## **DEVIATION REQUEST AND DECISION FORM**

Project Name : Claremont Business Park 2 Filing No. 2

A deviation from the standards of or in Section **2.2.4.B.6/SD-4-1** of the Engineering Criteria Manual (ECM) is requested.

**EL JEFE HEIGHTS**  
**URBAN LOCAL CROSS SECTION (PRIVATE)**  
\*POSTED SPEED 25 MPH\*  
\*DESIGN SPEED 30 MPH\*

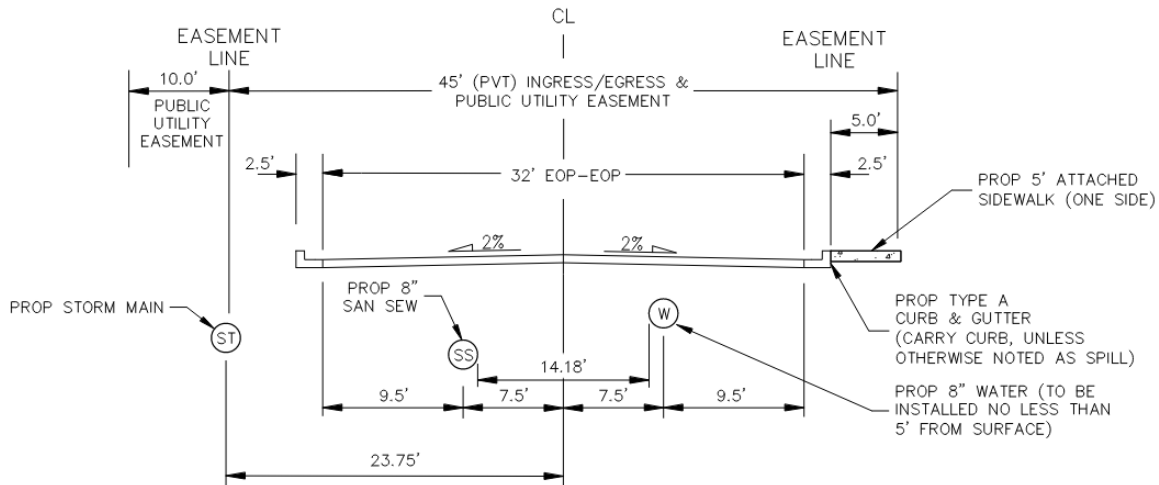
Request to deviate from the standard Local Urban Road Section ECM Section 2.2.4.B.6/SD-4-1. The private roadway section shall meet all details of the Local Urban Road Section except requests to exclude the 5' wide sidewalk (each side) as defined in the detail and provide a 5' wide sidewalk on the (1) one side only.

Applicant proposes to construct a full 32' wide asphalt mat with standard curb and gutter types with the exclusion of the typical 5' sidewalk as detailed in the Local Urban Road Section ECM Section 2.2.4.B.6/SD-4-1. It's the applicants request to construct the roadway per the ECM Section 2.2.4.B.6/SD-4-1, without the 5' sidewalk and provide a 5' wide sidewalk on (1) one side only, and request to deviate from the standard 30' wide asphalt mat to a 32'.

Approval is for the cross section below copied from the Construction Drawings.

This request has been determined to have met the criteria for approval. A deviation from Section 2.2.4.B.6/SD-4-1 of the ECM is hereby granted based on the justification provided.
